EDWIN I. HATCH NUCLEAR PLANT UNIT NO. 1

AMENDMENT TO FACILITY OPERATING LICENSE

Amendment No. 33  
License No. DPR-57

SAFETY EVALUATION BY THE OFFICE OF NUCLEAR REACTOR REGULATION

FIGURE 3.11-1 (Sheet 1)

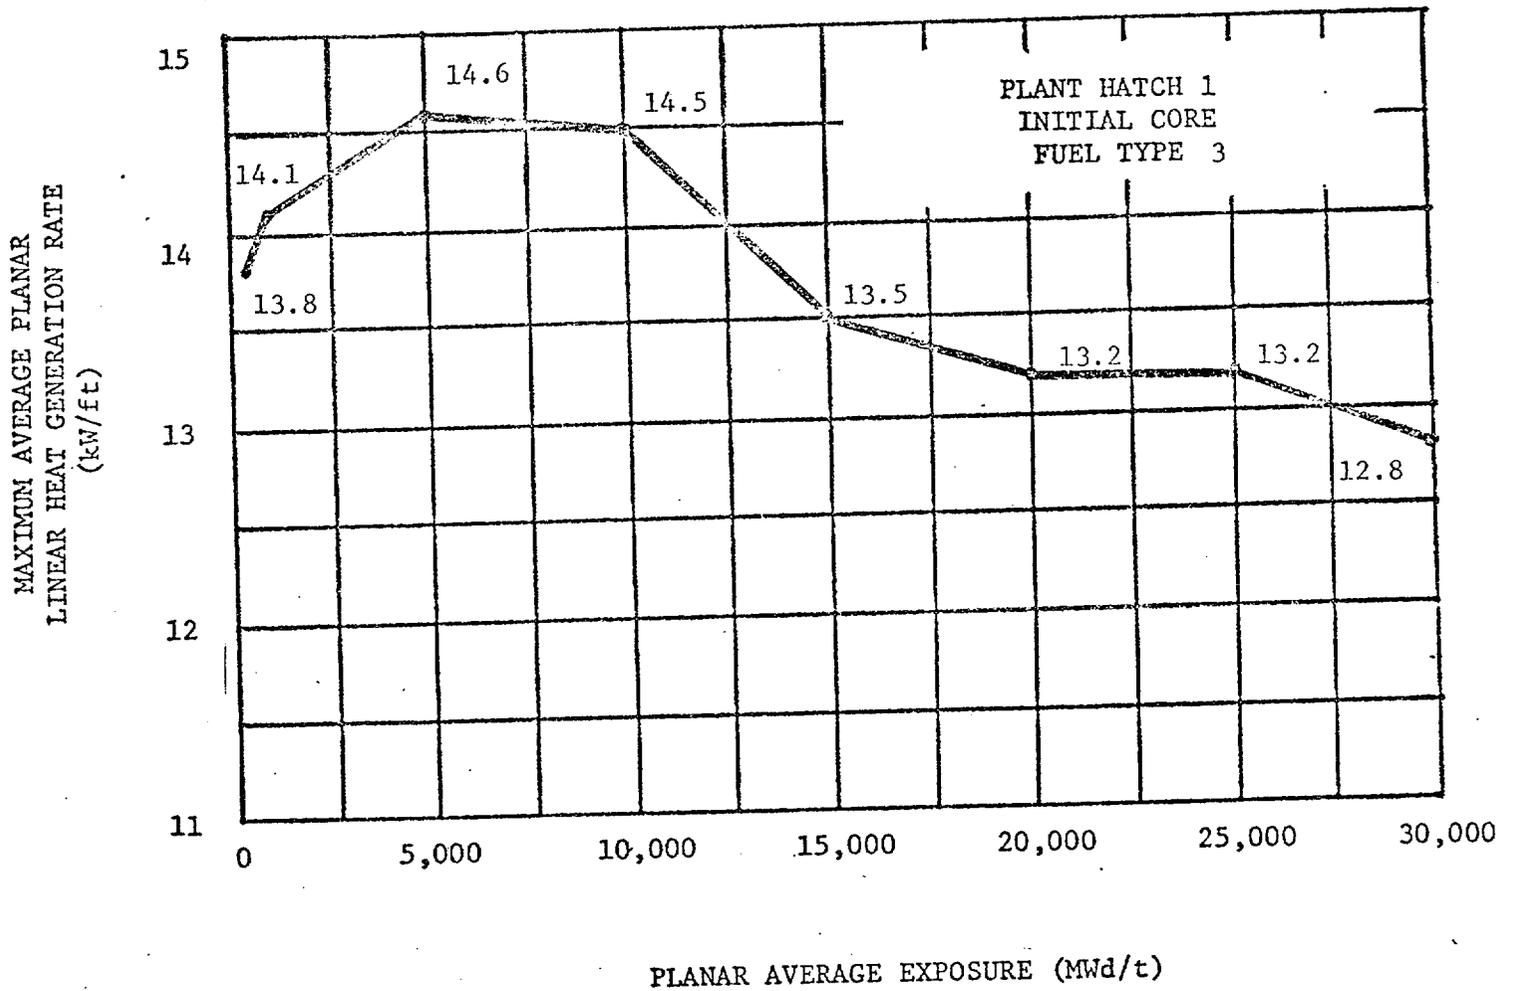
Replace pages 1.1-6, 1.1-7, 1.1-8, 3.5-3, 3.5-4, 3.5-15, 3.6-22, 3.11-3, 3.11-4, 3.11-5, Figure 3.11-1 (Sheet 1) and Figure 3.11-1 (Sheet 2) with the attached revised pages. Add page 3.11-6.

The peak cladding temperature following a postulated loss-of-coolant accident is primarily a function of the average heat generation rate of all the rods of a fuel assembly at any axial location and is only dependent secondarily on the rod to rod power distribution within an assembly. Since expected local variations in power distribution within a fuel assembly affect the calculated peak clad temperature by less than  $\pm 20^{\circ}\text{F}$  relative to the peak temperature for a typical fuel design, the limit on the average linear heat generation rate is sufficient to assure that calculated temperatures are within the 10CFR50, Appendix K limit. The limiting value for APLHGR is shown in Figures 3.11-1, sheets 1 and 2.

The calculational procedure used to establish the APLHGR shown in Figures 3.11-1, sheets 1 and 2, is based on a loss-of-coolant accident analysis. The analysis was performed using General Electric (GE) calculational models which are consistent with the requirements of Appendix K to 10 CFR 50. A complete discussion of each code employed in the analysis is presented in Reference 1. Differences in this analysis as compared to previous analyses performed with Reference 1 are: (1) The analysis assumes a fuel assembly planar power consistent with 102% of the MAPLHGR shown in Figure 3.11.1; (2) Fission product decay is computed assuming an energy release rate of 200 MEV/Fission; (3) Pool boiling is assumed after nucleate boiling is lost during the flow stagnation period; (4) The effects of core spray entrainment and counter-current flow limiting as described in Reference 2, are included in the reflooding calculations.

With the LPCI modification completed, the limiting break is the complete severance of the recirculation discharge line (break size of 2.366 ft.<sup>2</sup>) assuming a simultaneous failure of the LPCI injection valve for the unbroken loop to open. Under such conditions, two Core Spray systems, the High Pressure Coolant Injection (HPCI) system, and the Automatic Depressurization System would be available for core cooling. This "worst-case" ECCS availability results in a faster core reflood time than that which existed for the limiting break and worst single failure for Hatch Unit No. 1 with the unmodified LPCI system. The core reflood time is improved by approximately 120 seconds for the bottom of the core and by approximately 150 seconds for the top of the core. This improved core reflood time allows an increase of approximately 10% in the maximum average planar heat generation rate limits.

We have reviewed the evaluation of ECCS performance with the LPCI system modifications submitted by GPC for Hatch Unit No. 1 and conclude that the evaluation is based on an acceptable evaluation model and has been performed wholly in conformance with the requirements of Section 50.46. Therefore, operation of the reactor would meet the requirements of Section 50.46 provided that operation is limited to the maximum planar linear heat generation rates (MAPLHGR) of Figure 3.11-1, sheets 1 and 2, of the GPC submittal of April 9, 1976 and to a minimum critical power ratio (MCPR) greater than 1.17. The above mentioned MAPLHGR curves appear as limiting conditions for operation in Technical Specification 3.11.A. A minimum operating MCPR limit of 1.32 is assured by Technical Specification 3.11.C.
